# United States Department of the Interior

ER-13/0137

The Department of the Interior (Department) has reviewed the Department of State's Draft Supplemental Environmental Impact Statement (DSEIS) for the Keystone XL Pipeline Presidential Permit. The Department offers the following comments and recommendations for your consideration.

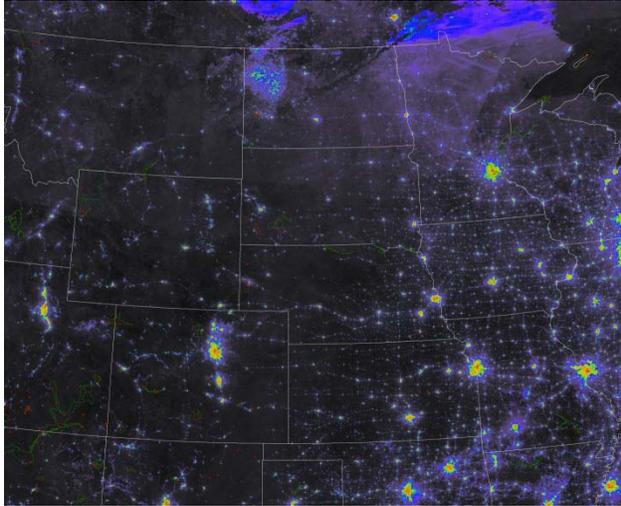
Lighting needs, lighting types, light pollution and lighting impacts are not adequately addressed in the document. Site plans for aboveground installations (from previous planning documents) do not include lighting schematics. Further information and analysis regarding lighting along the pipeline and in the vicinity of national trails and the Niobrara NSR is recommended in order to assess the impacts to park resources.

This 2012 NASA Earth Observatory image of the central United States shows light sources in the central plains. Much of the proposed pipeline route has little anthropogenic light and, therefore, has high quality night skies. The cumulative effects of the project could adversely impact the quality of the night skies and the overall photic environment.

The Department recommends that: additional analysis of the direct and cumulative effects from lighting in this project be conducted; aboveground facilities be located as far away from park units as is feasible; mitigation measures such as shielded, full-cutoff

lighting, timers, and motion sensitive switches should be used, where possible; and the minimum amount of illumination be used for tasks commonly carried out along the pipeline.
